**From:** Detterman, Mark, Env. Health  
**Sent:** Tuesday, August 23, 2016 4:08 PM  
**To:** 'Ricks, Zantha'  
**Subject:** RE: PG&E Notification for Electric Pole Replacement Project 31193311 Near FIDELITY ROOF COMPANY (T0600102117) in Oakland

Case No. T0600102117, FIDELITY ROOF COMPANY, 1075 40<sup>th</sup> Street, Oakland CA 94608

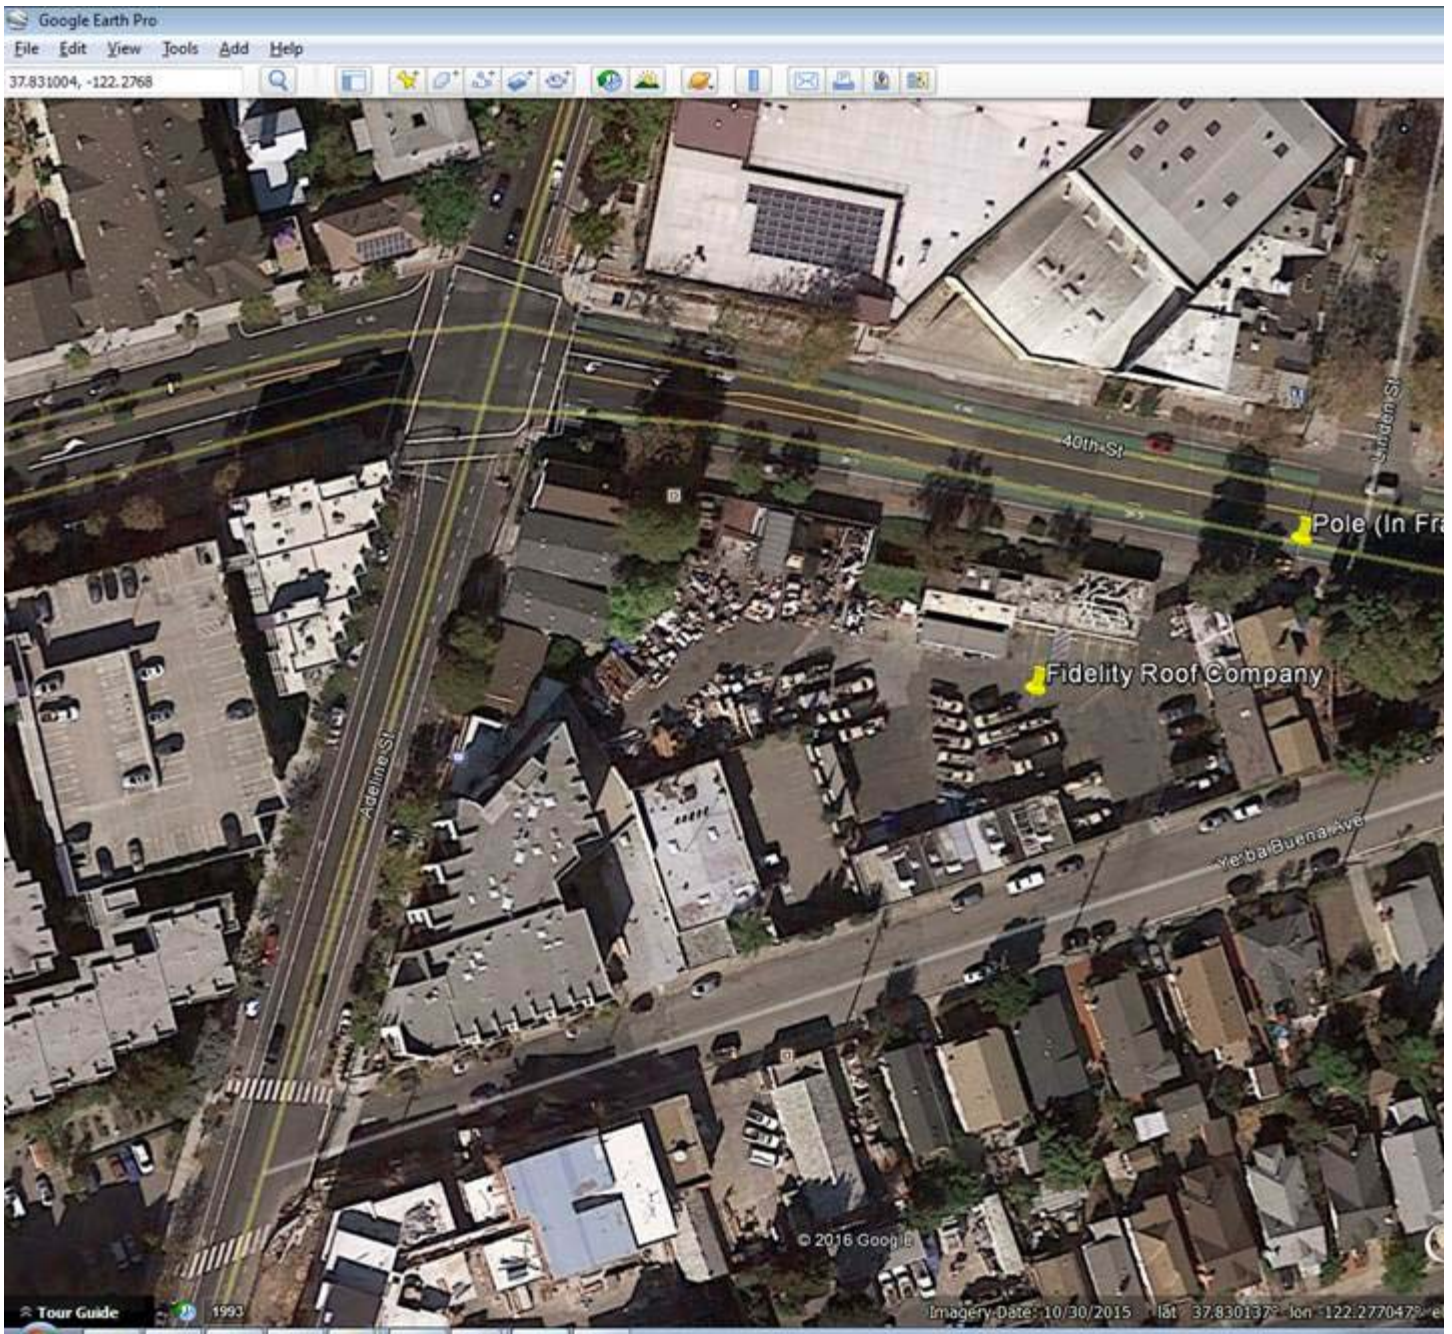
The project involves the replacement of one electric distribution pole. The replacement of the pole involves the removal of the existing pole and placement of a new pole in a 6-8 foot deep excavation. The approximate location of the project is below.

Based on information available on Geotracker, contamination was not encountered in MW5 (nearest our work area) during the final groundwater sampling event in November 2011. Can you please indicate if you have additional information for contamination in the project work area, or if you have any additional requirements for our planned work to commence? The project is currently scheduled to take place on October 12th, 2016, and should only take one day.

In regards to the Fidelity Roofing site, no additional information has been generated since case closure in May 2013. The predominate groundwater flow direction was to the northwest, so I would consider there to be a relatively low likelihood of encountering contamination from the site at the pole replacement location. Depth to groundwater at well MW-5 was no shallower than approximately 9.2 feet below grade surface at that time, so your crew may not encounter groundwater.

In regards to the California Linen Supply site, you will need to communicate with Mark Johnson of the RWQCB as he has been working that site more recently than the County, and may know more current information. While ACDEH managed that case, there was a slightly higher probability of contamination from that site to impact your current work area.
